World Forum for Harmonization of Vehicle Regulations

Proposal for amendments to the Consolidated Resolution

on the common specification of light source categories (R.E.5)

Proposal for amendment 7 to the Consolidated Resolution on the common specification of light source categories (R.E.5)

Figure 1
Main drawing

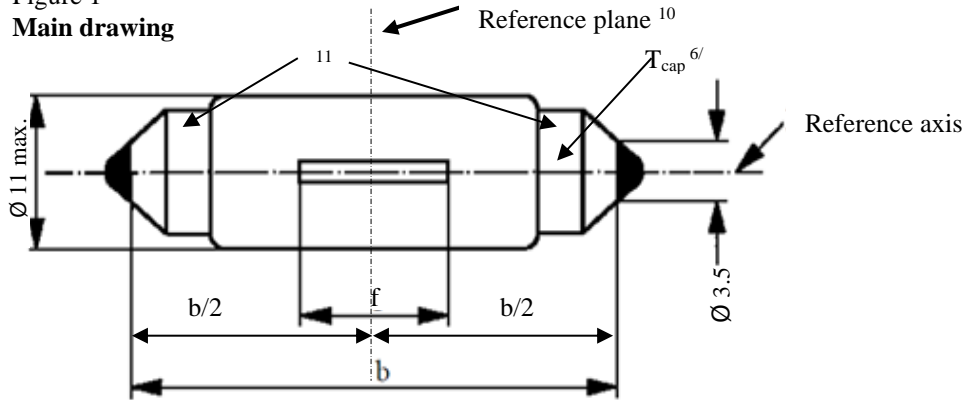
After sheet C5W1/LED/4, insert new sheets C5W_LED/1 to 4, to read:

Dimensions in mm		LED light sources of normal production	
b ^{1/}		35.0 ± 1.0	
f ^{2/}		9.0 nom.	
Elevated ambient air temperature ^{4/}		50°C	
Cap SV8.5 in accordance with IEC Publication 60061 (sheet 7004-81-4)			
Electrical and photometric characteristics ^{5/}			
Rated values	Volts	12	
	Watts	3 ^{9/}	
Test voltage (DC)	Volts	13.5	
Objective values	Power ^{7/}	Watts	2.5 min. ^{8/} 5.5 max. ^{9/}
	Electrical current ^{7/} at 12-14 V DC	mA	150 min. ^{8/}
	Luminous flux ^{3/}	lm	45 ± 20 %
	Luminous flux ^{3/} at 9V DC	lm	9 min.
	Cap temperature T _{cap}	°C	75 max. ^{8/}

Figure 1
Main drawings

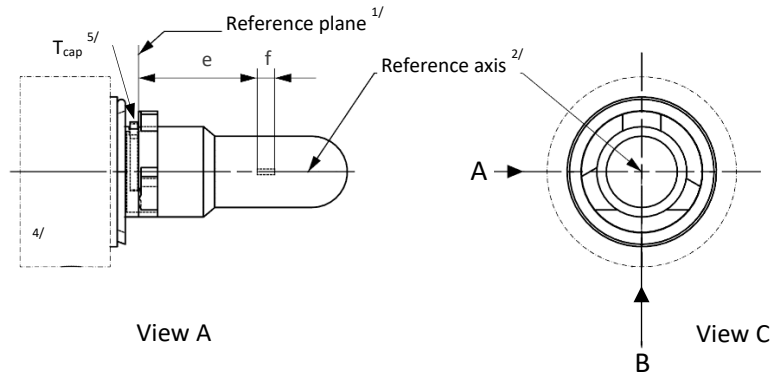
After sheet H11/LED/7, insert new sheets H11_LED/1 to 7, to read:

- ^{1/} The reference plane is the plane formed by the underside of the bevelled lead-in flange of the cap.
- ^{2/} The reference axis is perpendicular to the reference plane and passing through the centre of the 19 mm cap diameter.
- ^{3/} The LED light source shall not exceed the envelope as indicated in Figure 2.
- ^{4/} The light source shall function in either voltage polarity.
- ^{5/} Measurement point for cap temperature T_{cap}
